DEVELOPMENT REVIEW COMMITTEE (DRC) COMMENT REPORT

PROJECT NAME: Furniture Showroom

CASE NUMBER: UDP-S23054

REQUEST: Site Plan Level II Review: 4,550 Square-Foot Commercial Development

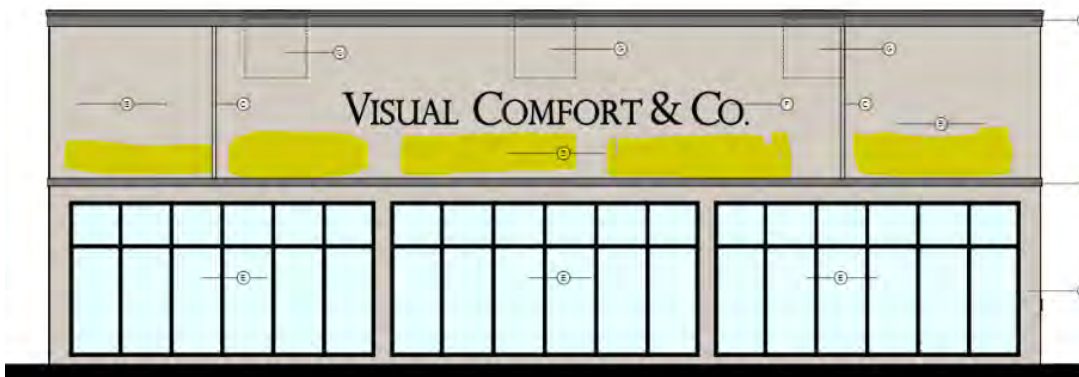
- 9. Provide the following changes on elevations:
a. Elevation labeling is transposed. Update elevation labeling on Sheet, A-11 and Sheet, A-12 to show the correct direction of the façades.
b. Provide additional architectural elements to the north and south façades to break up the large flat surface areas such as awnings, shutters, and/or additional windows.
c. Wrap the windows further around the corners of the southwest and northwest corners of the building.
d. Consider integrating transom windows along the western façade along North Federal Highway, below the wall sign to break up the large blank surface area.

- e. Consider thicker cornice and banding to better match the scale of the building, that also projects out further to help add depth.
f. Provide additional high-quality durable materials to enhance the façades.
